January 14, 2022

PND 222019

Re: Yakutat High School Roof Snow Load Assessment
Structural Engineering Report

Inspection Photos

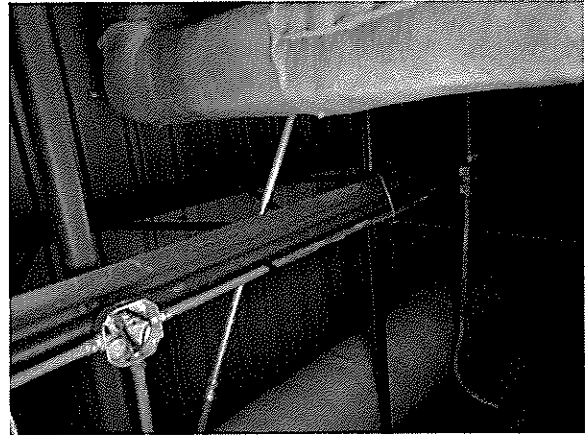
- 2) There is cracking in finishes at the lobby/hallway adjacent to the superintendent's office and in the receptionist office. The damage is not a structural concern, but is evident even under low to moderate load on the roof as structural framing deflects.

- 3) There are bent web members in a steel joist over the receptionist office. It is not known whether these were caused by excessive snow loads or were damaged during construction and have not been noticed until this inspection.

Ceiling transition at High School Lobby/Corridor has cracks on each end: Roof trusses are not supported by this but when they are moderately loaded the trusses push this 2x framed box beam down and the gypsum wall board cracks

False Header in Receptionist Office: Not a structural member and can be removed. This is pushed down when roof trusses are moderately loaded

Roof joist above Receptionist Office with bent web members.

- 4) Remove the false header at the reception room. There is a gypsum wall board finished, 2x4 framed, false header below the suspended acoustical ceiling. It is an aesthetic feature that has no structural value. It is moved and loaded when roof framing above deflects. It is not structural and it unnecessarily causes concern when roofs are loaded with a moderate load (below the snow design load).

- 5) The steel joist with bent web members should be repaired. Either the bent sections of the diagonal web be heated and then mechanically pushed into a relatively straight condition or new additional bars be welded either side of the bent section and welded to the top and bottom cord. The bending to straight alternative should only be done by a person experienced in that type of work. Welding additional pieces should be done by an experienced welder with certification to perform fillet welds. The paint at the weld area needs to be removed by grinding. Place a 5/8 inch diameter bar on each side and parallel to the bent member then weld each end with a 1/4 inch flared bevel weld on each side of the bar. The bars should be bare steel or have their paint removed at the weld area.

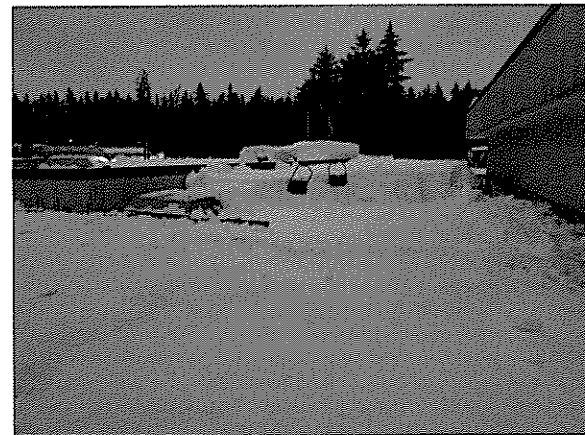
Snow removal at Elementary School, south side of building. 4 feet of depth was measured.

Extent of snow removal over main entry of High School. Depth similar to Elementary School.

Snow mostly removed from east side of High School

- 1) Continue the snow removal program. As noted in the 2007 and 2013 investigation reports the following guidelines should be used:
